RE: Ore Peninsula Redevelopment Project, Pacific Pile & Marine
Change Order No. 005

Date: March 5th 2024

Scope of Changes (Change Order 005):

Subject: Ore Peninsula Redevelopment Project
RFP – Upland Slab – PCO 003

1601 5th Avenue, Suite 1300 Seattle, Washington 98101 (206) 382-0600 Fax (206) 382-0500	RFI 005 RESPONSE	PROJECT NO.: 2100135	SHEET NO. 2 OF 2
	Skagway	DATE: 2023-08-14	
		BY: DMR

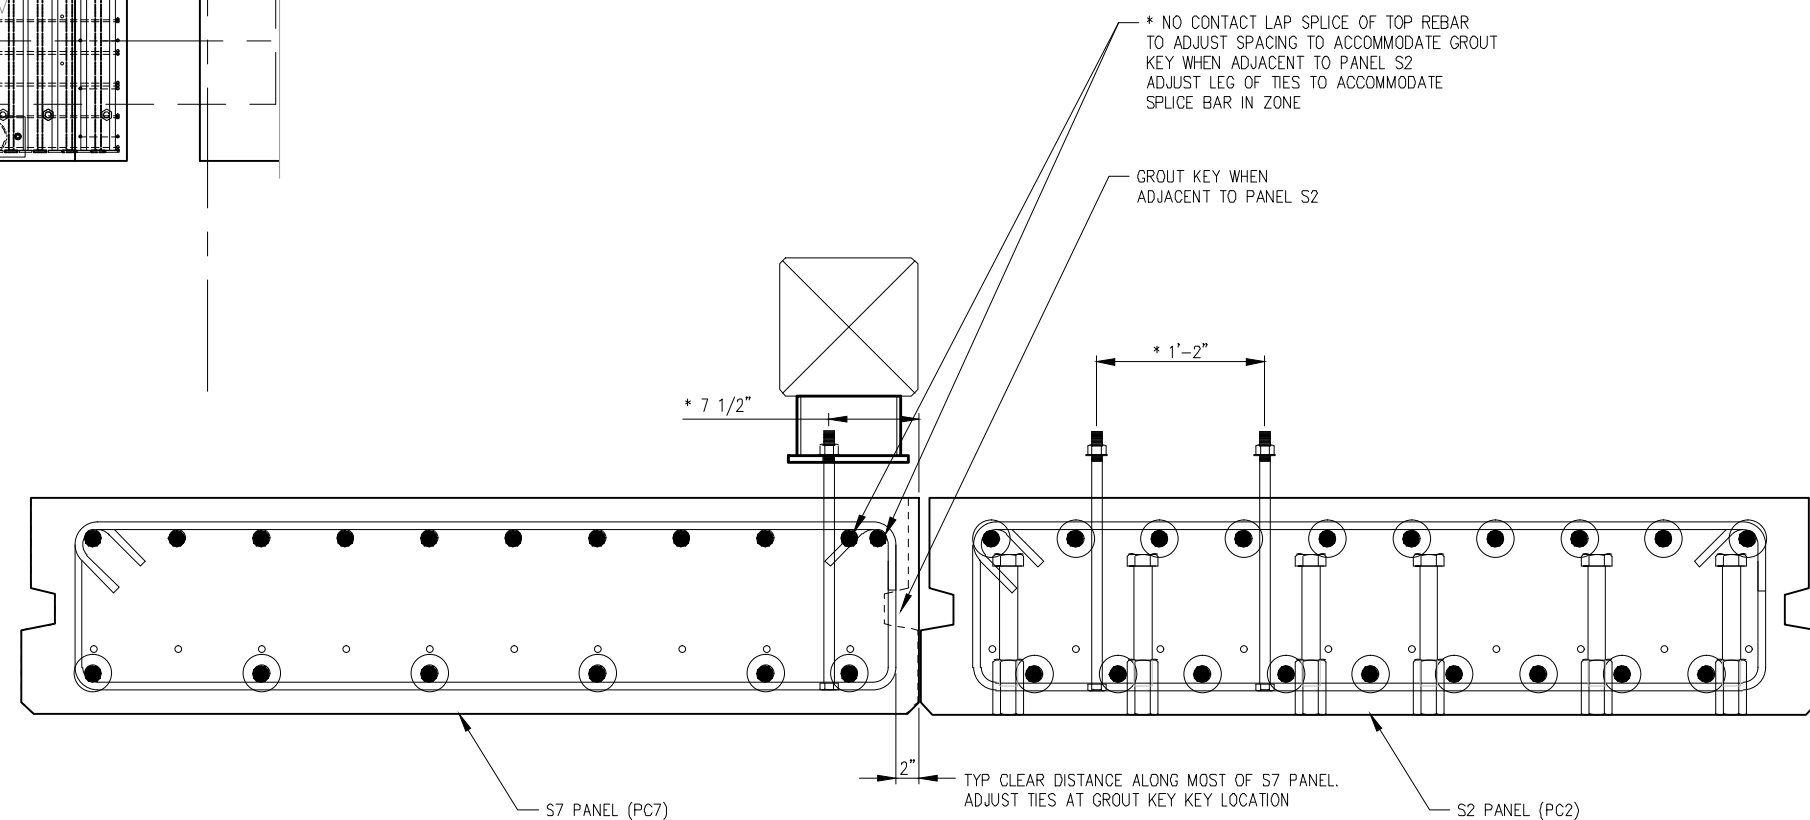
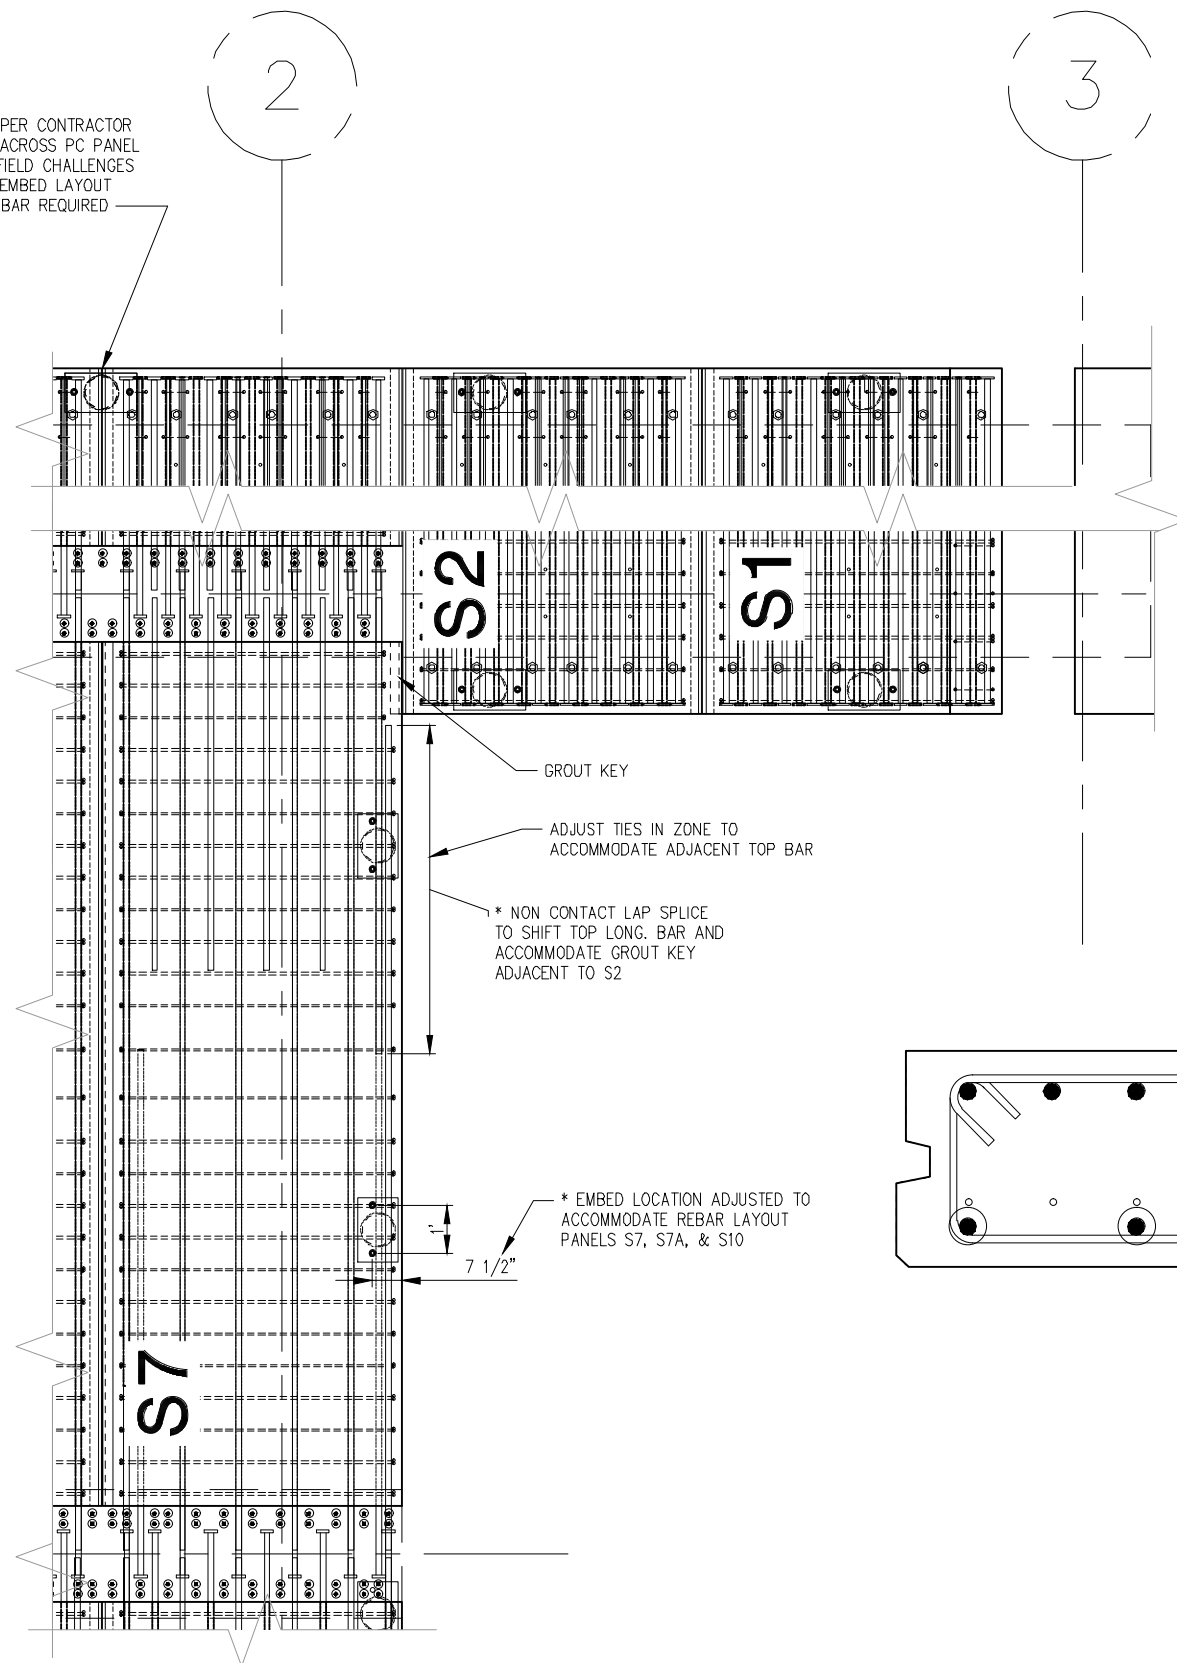
BULL RAIL RISER LOCATION PER CONTRACTOR RFI 11. LOCATING EMBEDS ACROSS PC PANEL GROUT JOINT MAY CREATE FIELD CHALLENGES CONTROLLING TOLERANCES. EMBED LAYOUT AND COORDINATION WITH REBAR REQUIRED

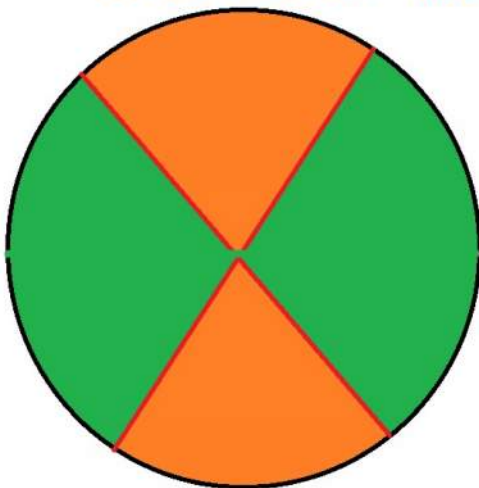
Today with Dan and Nicole there was a slight roundness issue observed with the fully coated section of Pile 8 that was discovered during splicing preparation and fit up.

Dan, Nicole, and I collected measurements of the pile diameter at several locations and noted there appears to be a minor diameter discrepancy in about $\frac{1}{4}$ of the pile's cross section. The pile is slightly smaller than 40" inside diameter in this area as best measured in the sketch below.

~39 1/2" to 39 3/4" I.D.

40" Inside Diameter

This backing material fit up will require some rework by PPM, and we will plan to verify the root weld if possible with our welding inspector during continuous visual inspection.

DRAWN: MSM	PROJECT NO.: 10849.22001
DESIGN: MSM	SCALE: AS SHOWN
CHECKED: JMP	DATE: 08/04/2023
DRAWING NO.	C2.00
SHEET NO.	1 OF 1

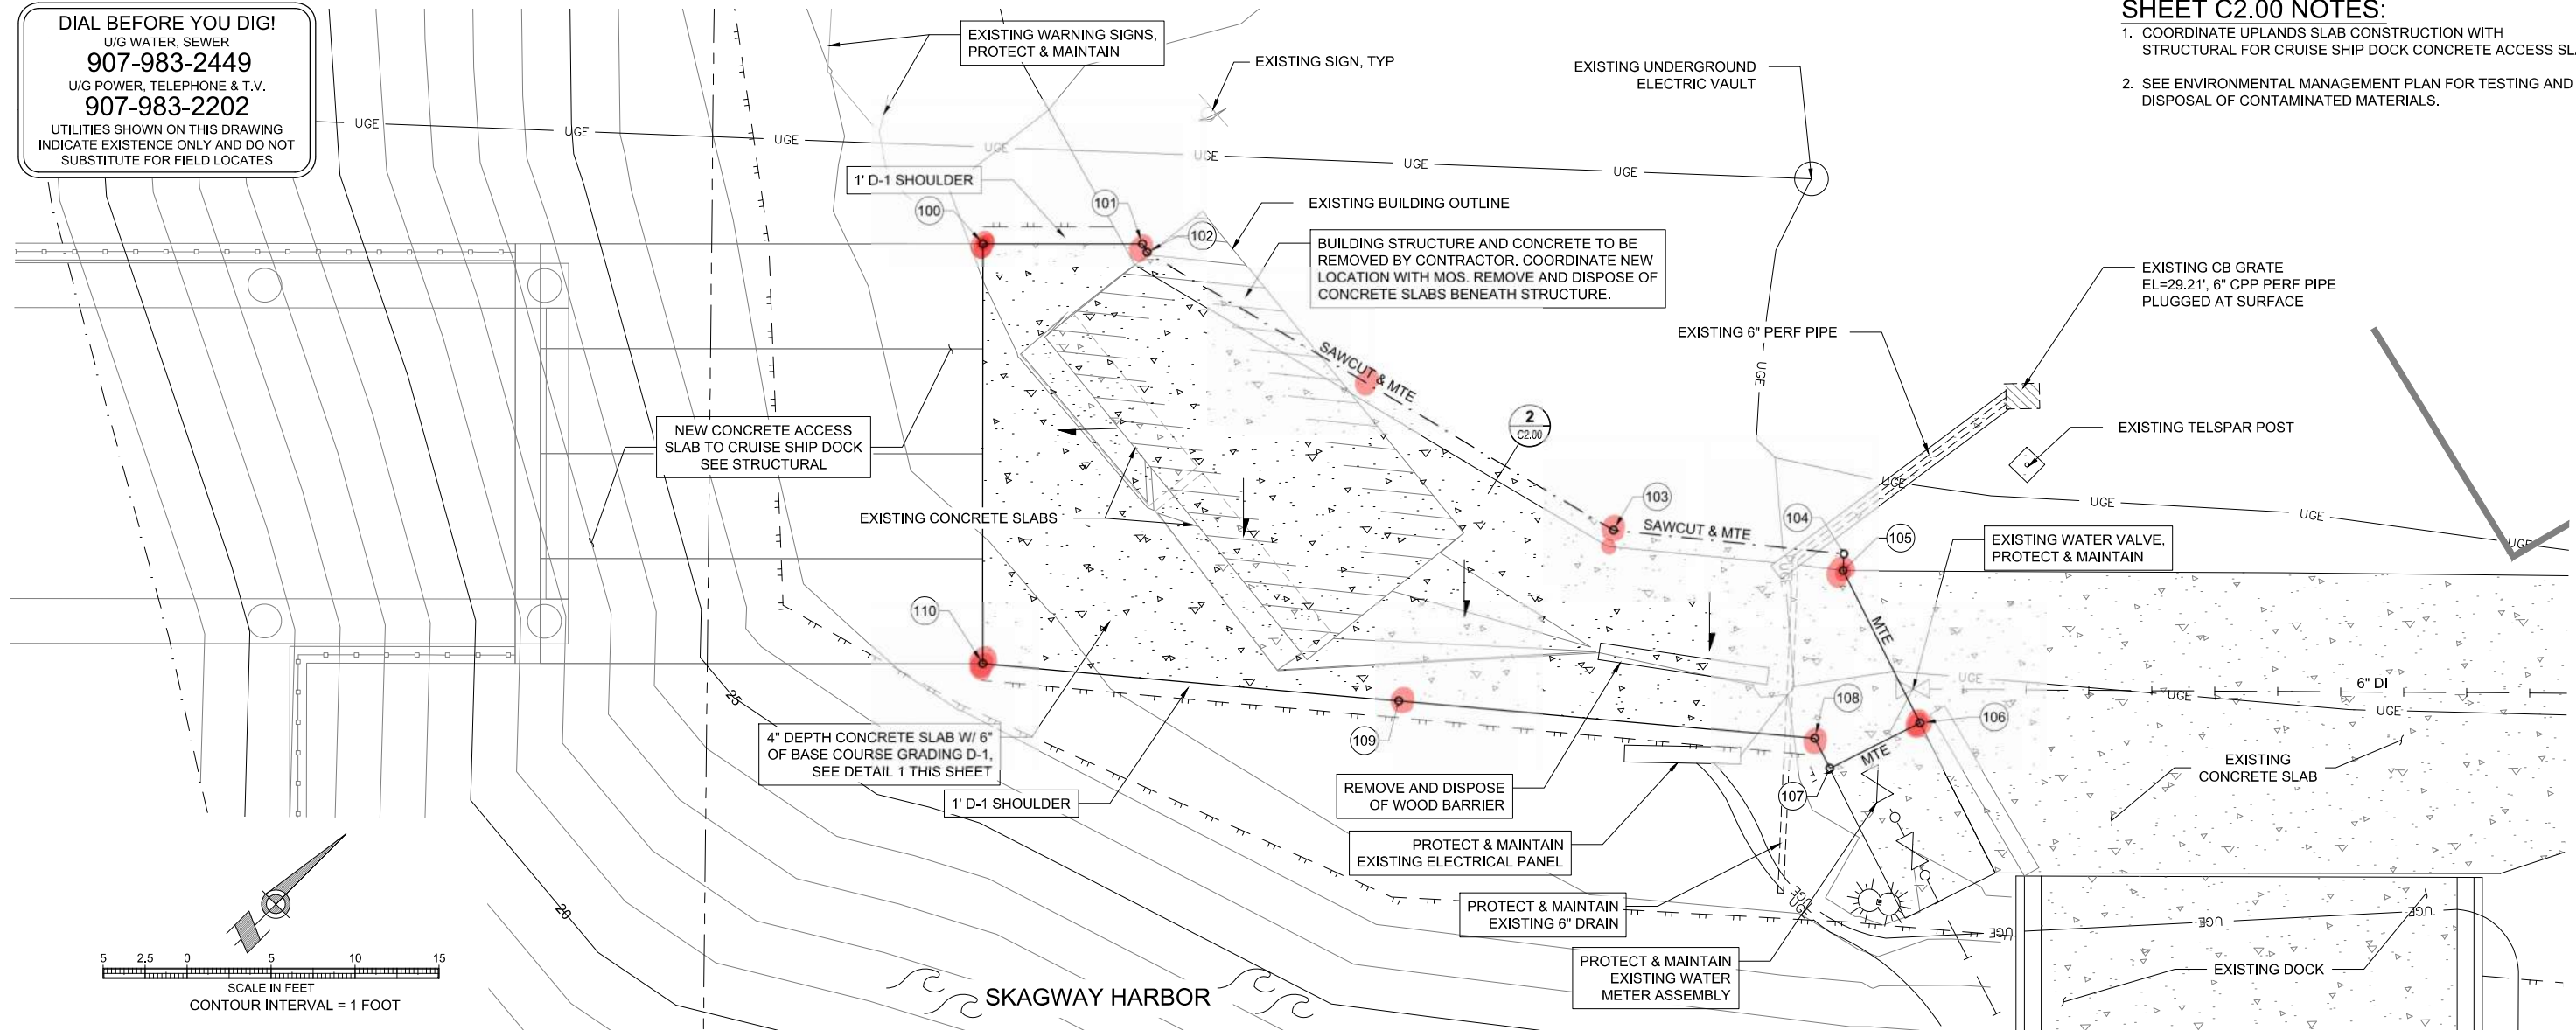
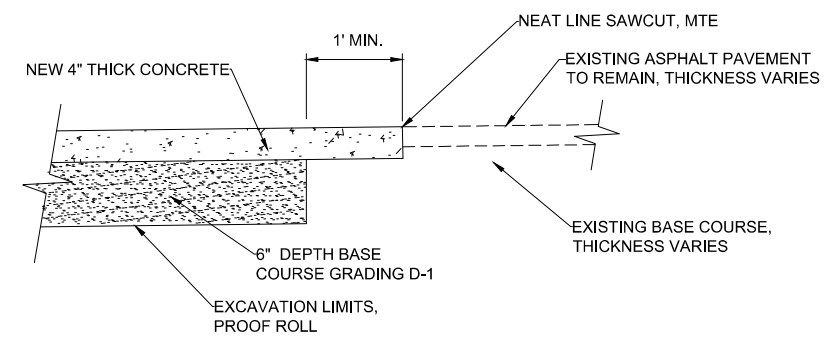
This Field Order is provided to Pacific Pile and Marine (PPM) as written direction to perform survey collection of the existing elevations at the survey points shown in the attached field sketch.
